DEVELOPMENT APPLICATION NO: 202139509

DEVELOPMENT APPLICATION NO: 201935273

Description: PROPOSAL FOR ESTATE DEVELOPMENT PLAN - Subdivision of block 1210 into 24 IZ1 General Industry blocks. Construction of associated roads, utilities, verge crossings, footpaths, landscaping and associated works. LEASE VARIATION - a variation of the Crown lease to delete clauses relating to variation for process, conservation and boundary fences, vary the carparking clause to a standard acceptable to the Territory and include the following uses: bulk landscape supplies, communications facility, craft workshop, defence installation, freight transport facility, general industry, industrial trades, light industry, warehouse, plant and equipment hire establishment, recycling facility, scientific research establishment, store, indoor recreation facility, municipal depot, public transport facility, transport depot and warehouse.

**CONSOLIDATED COMMENTS
TUGGERANONG BLOCK 1210 – DRAFT ESTATE DEVELOPMENT PLAN
CIRCULATION 1 – 21 May 2018**

Figure 3: Proposed block subdivision

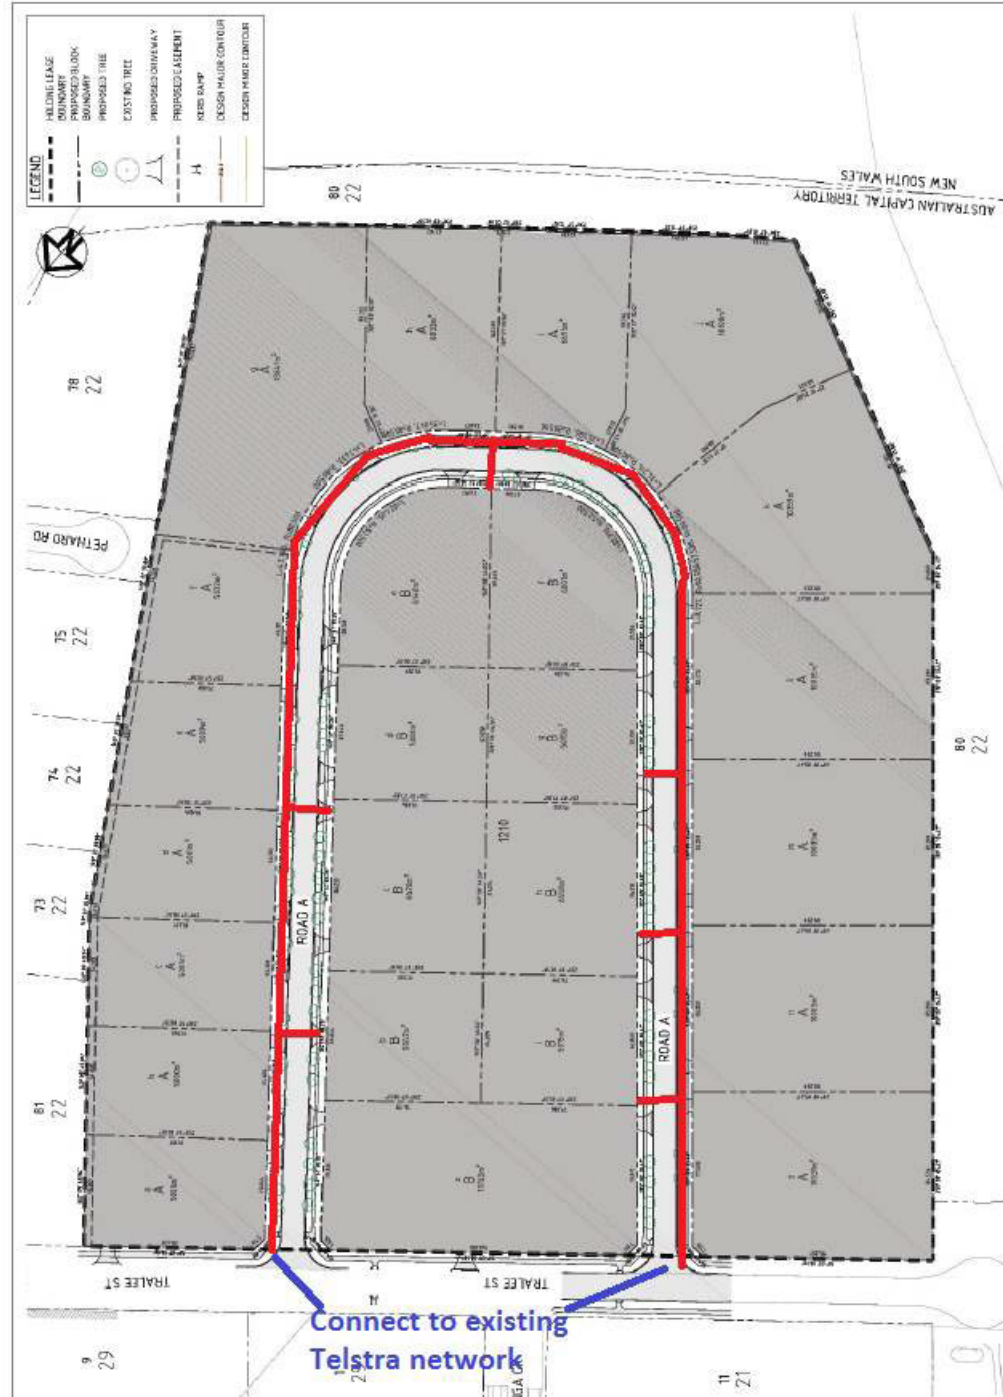
<p>Telstra Jacob Lai</p>	<p>19</p>	<p>Telstra require exclusive access to 1XP100 conduit and 1XP100 road crossing along Road A.</p> <p>Refer to attached schematic diagram for details.</p>
